UNITED STATES PATENT AND TRADEMARK OFFICE

09/955,351

Office Action Summary	Application No. 09/955,351	Applicant(s) LEE ET AL.	
	Examiner Michael Thaler	Art Unit 3731

FIG.2C

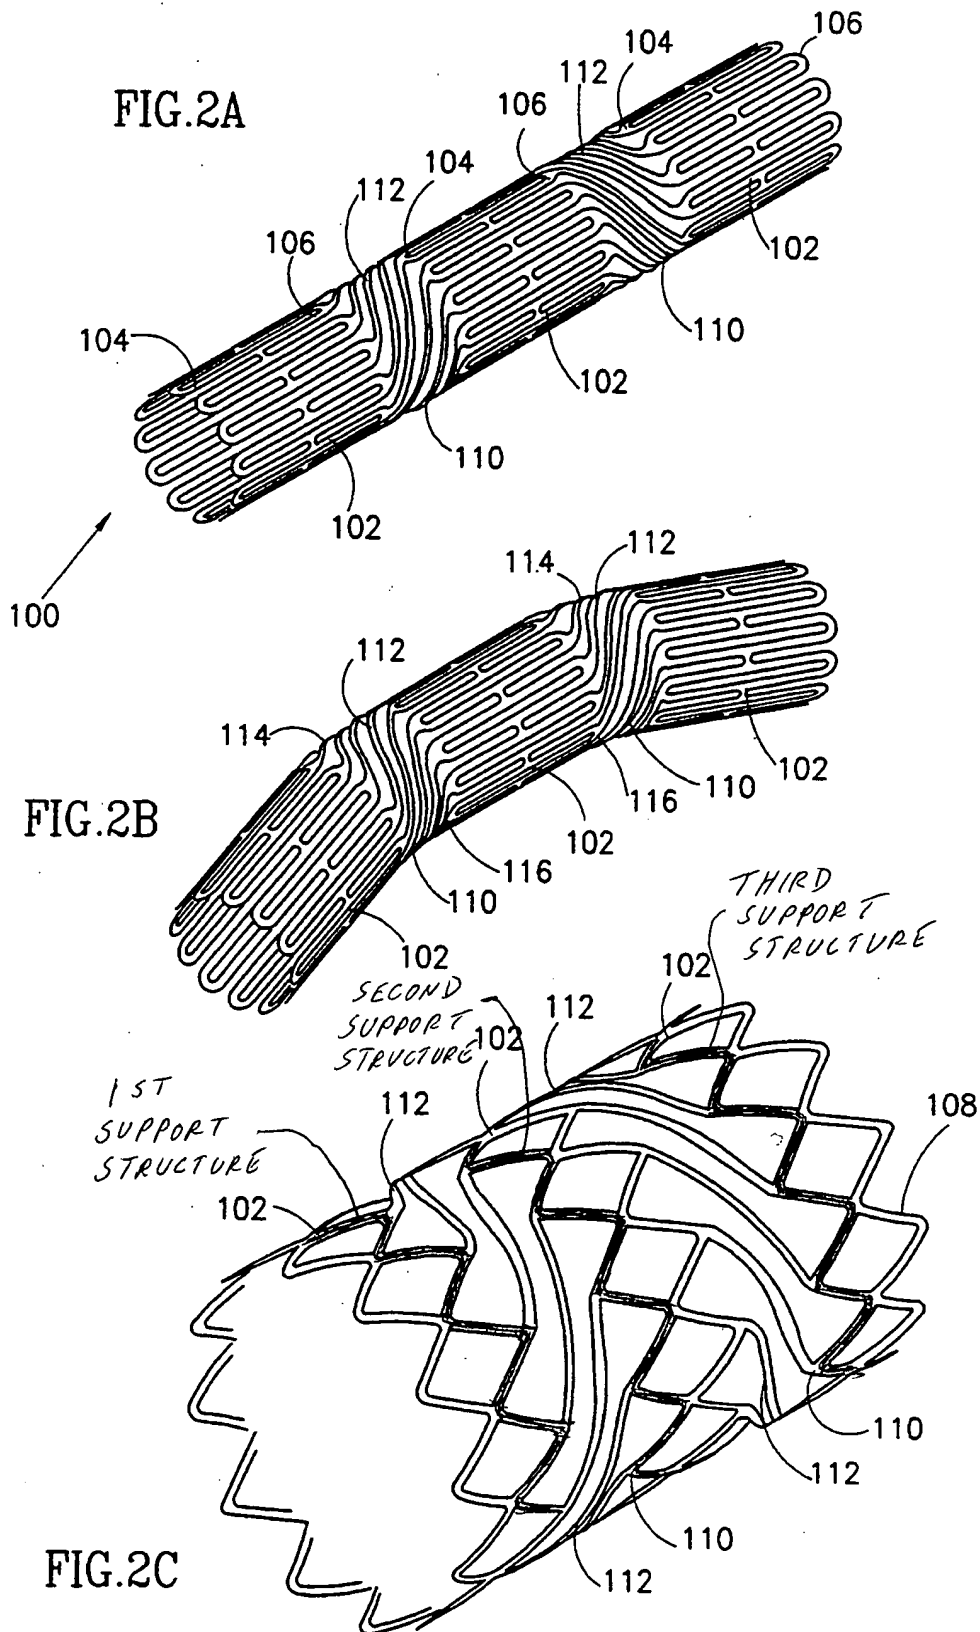
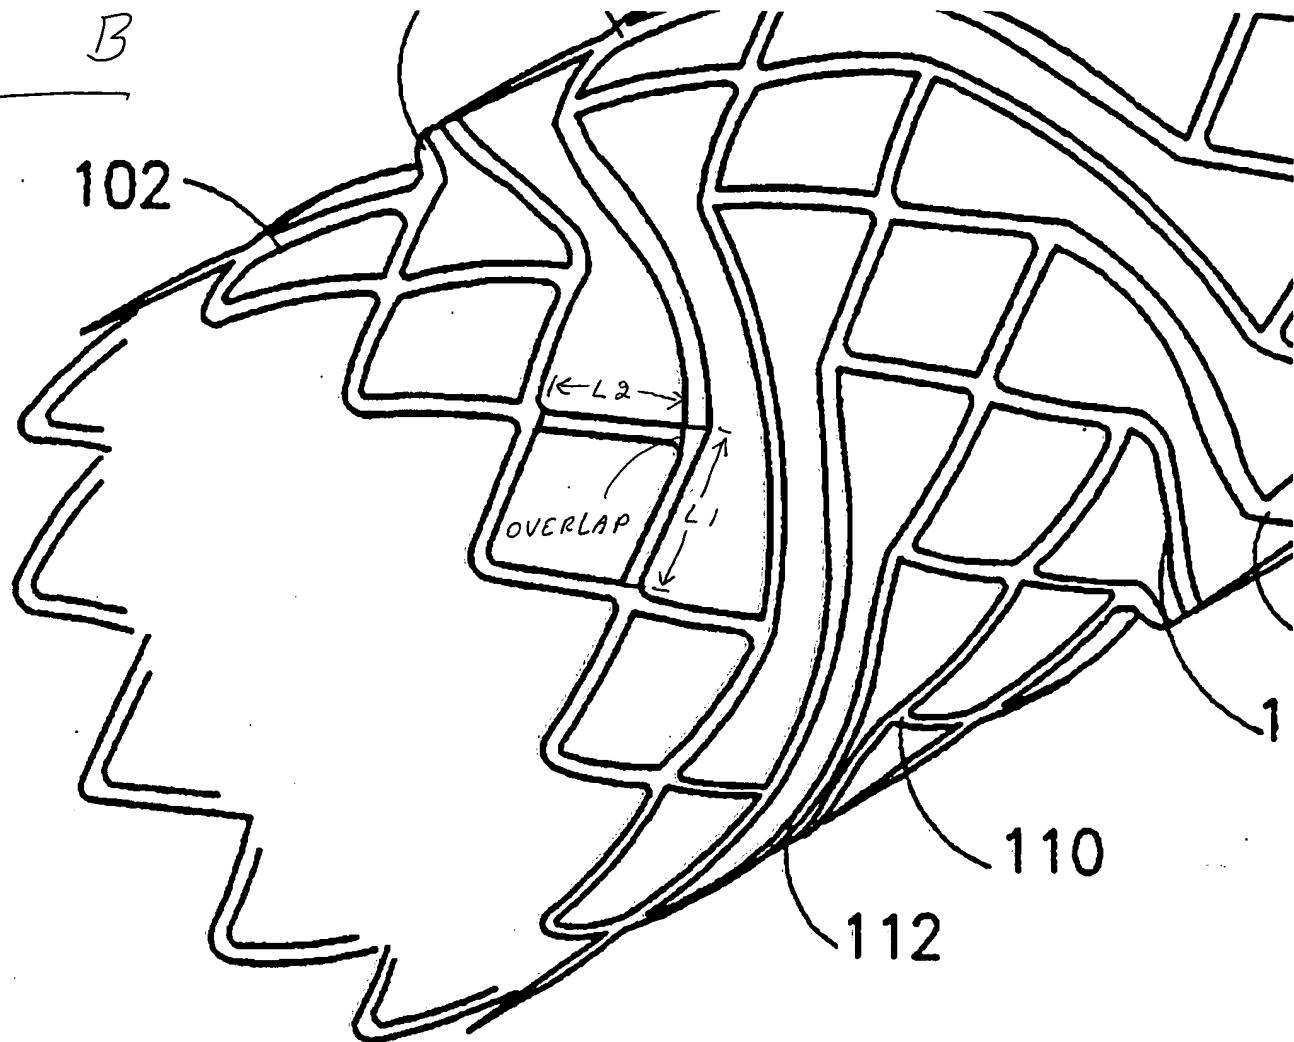
Claims 1, 9, 10, 12 and 21 are rejected under 35 U.S.C. 102(b) as being anticipated by Pinchasik et al. (5,449,373). Pinchasik et al. disclose a stent body having a plurality of adjacent circumferential support structures (each of the undulating members which form segments 102 and which are arranged in pairs) including longitudinal struts interconnected at apex portions, and circumferential connecting struts (e.g. 112) interconnecting a plurality, but not all of the adjacent circumferential support structures (since the paired circumferential support structures are directly connected together and thus are not interconnected by the circumferential connecting struts 112), the circumferential connecting struts extending between apex portions of adjacent circumferential support structures wherein said interconnected apex portions are circumferentially offset relative to one another (as seen in figures 2A, 2B and 2C). As to the indefinite language in claim 21, the angle between the Pinchasik et al. circumferential connecting struts and longitudinal struts is approximately the same as in applicant's invention. As to claim 9, the circumferential connecting struts on the left side of figure 2C of Pinchasik et al. extend in a first direction and the circumferential connecting struts on the right side of figure 2C extend in a second direction opposite the first direction.

Further, the circumferential connecting struts on the right side of figure 2C (in combination with half of a ring of cells 108) join the second and third support structures as shown in the attached appendix A. As to claim 10, some of the longitudinal struts (having length L1) are longer than other longitudinal struts (having length L2) and provide a longitudinal overlap as shown in the attached appendix B.

Applicant's arguments filed April 27, 2006 have been fully considered but they are not persuasive. The allegation on page 7 of the response that all apex portions of Pinchasik are interconnected by flexible connectors is incorrect. A ring of diamond cells 108 of Pinchasik includes two undulating adjacent circumferential support structures (i.e. one on the left half and one on the right as seen in figure 2C). These two adjacent circumferential support structures are directly connected together and are not interconnected by the circumferential connecting struts 112.
